ADDENDUM NUMBER 2:

Re: Crescent Lake Outfalls
Specification Number: PD 15-16.033

Revised Bid Documents

**PLANS PROPOSED FOR
 ENGFLOOD0414-91H
 CRESCENT LAKES
 OUTFALLS**

E3 - PLAN / PROFILE

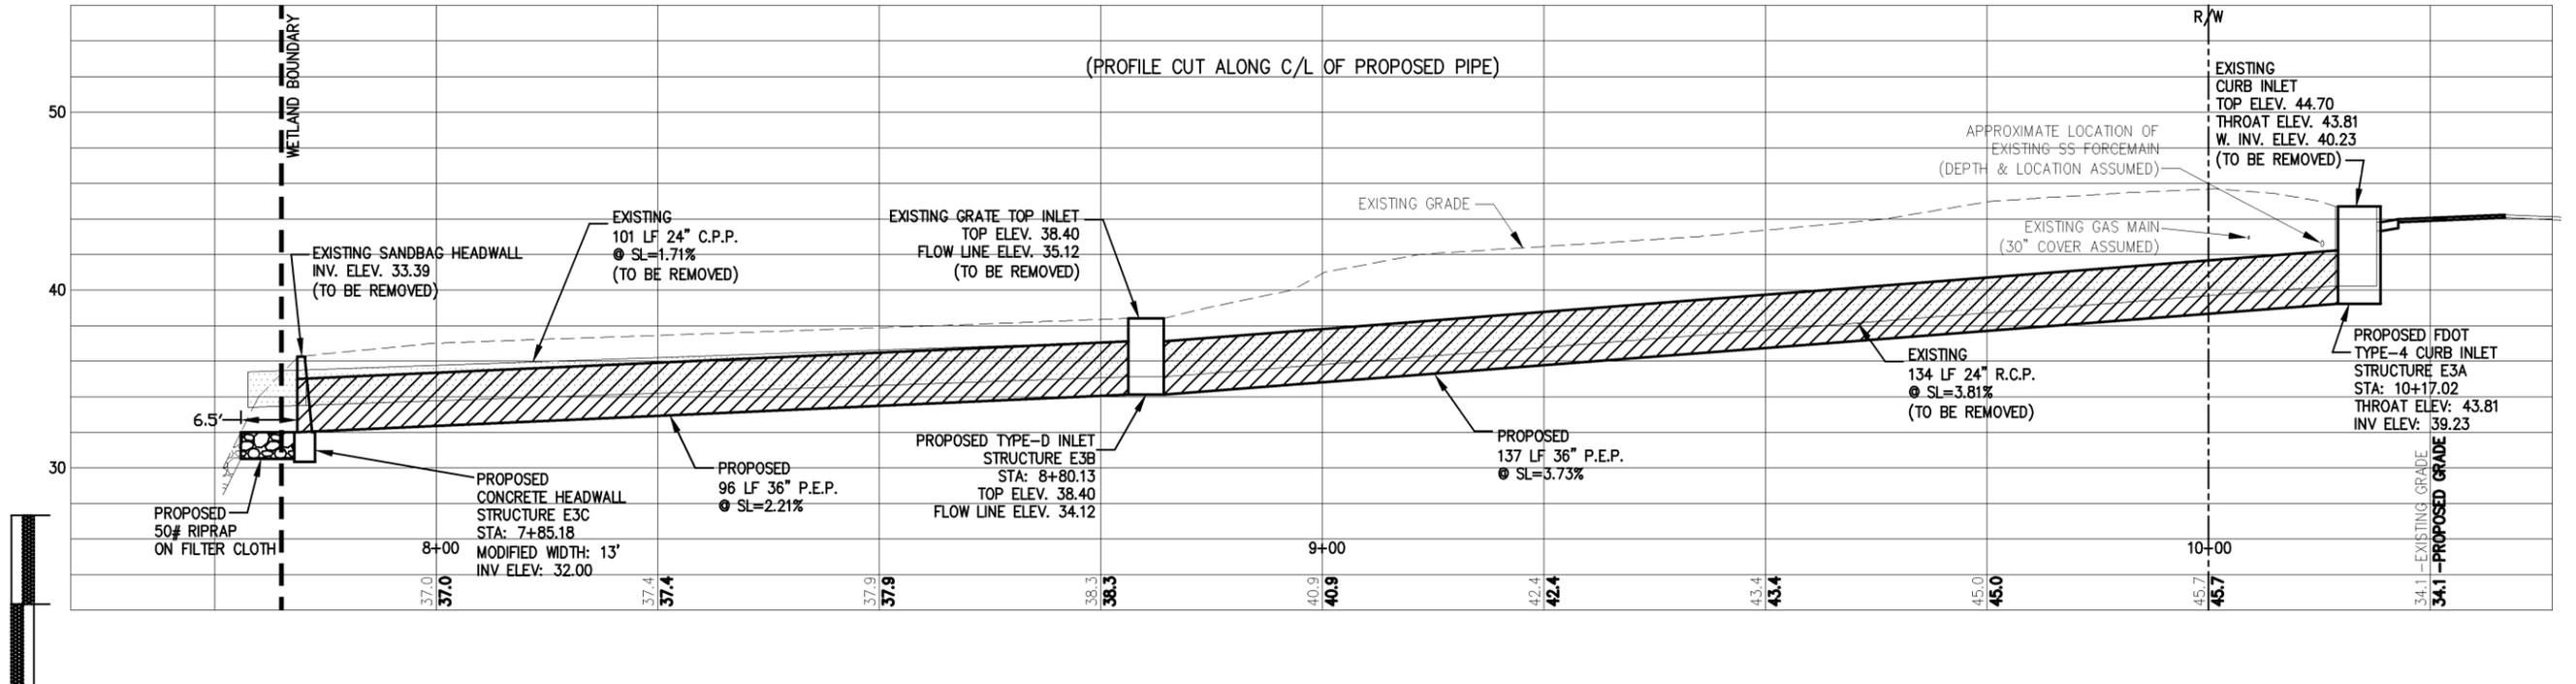
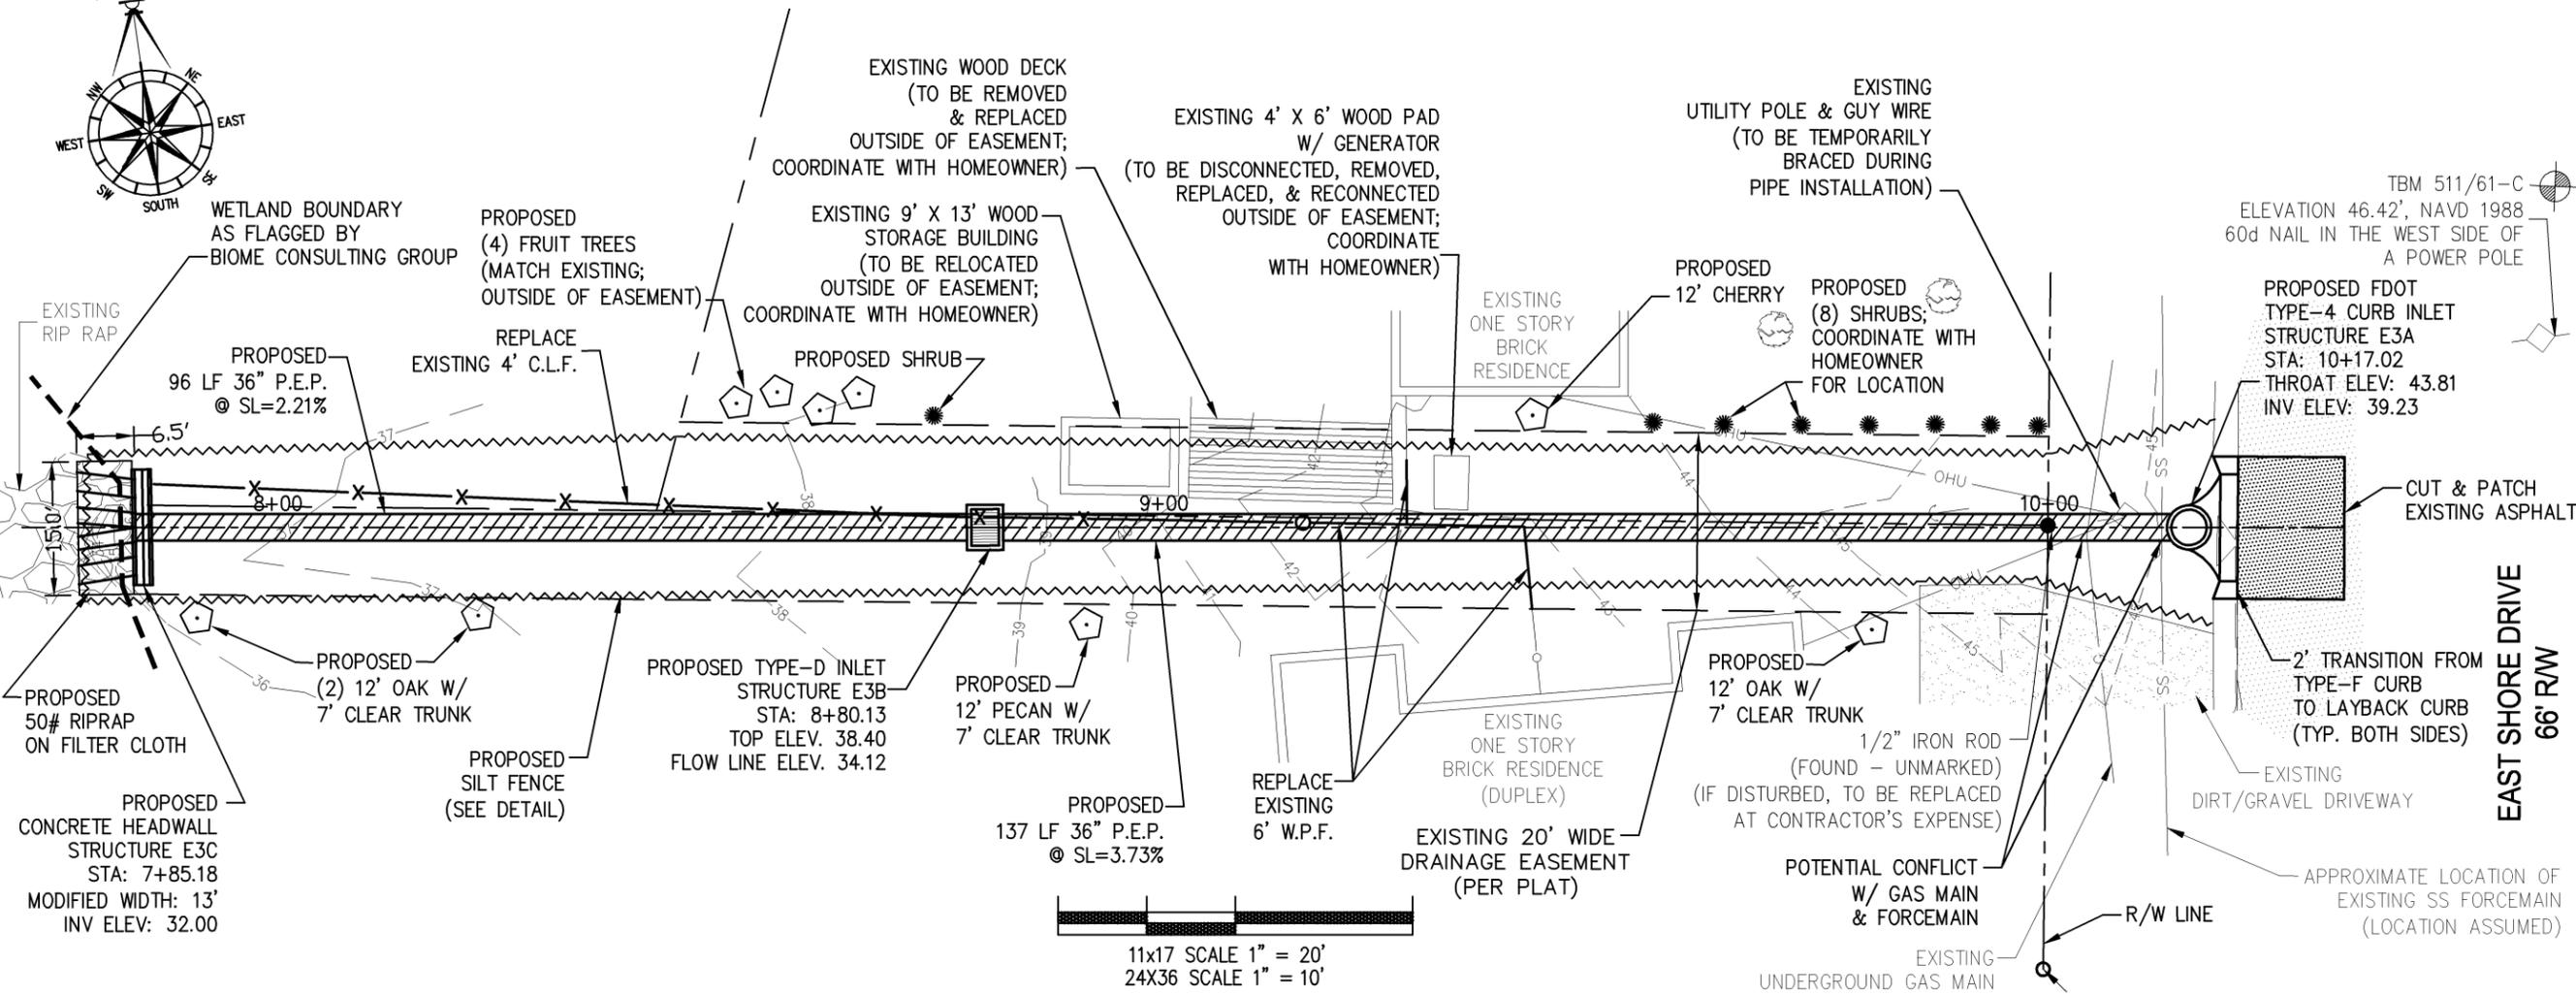
The existing curb inlet, storm pipe, drop inlet, and headwall are to be removed & replaced. The existing fencing and landscaping are to be removed & replaced as needed. The (2) wood decks are to be removed and replaced outside of easement. The existing storage building is to be relocated outside of easement. Contractor is to coordinate with homeowner for locations of each. East Shore Drive is to be cut & patched as required to replace the curb inlet. The proposed storm pipe will cross a force main and gas main. The pipe should be under both utilities without

is to be cut & patched as required to replace the curb inlet. The proposed storm pipe will cross a force main and gas main. The pipe should be under both utilities without conflict. The storm pipe will also be in close proximity to a utility pole. The contractor is to temporarily brace pole during pipe installation.
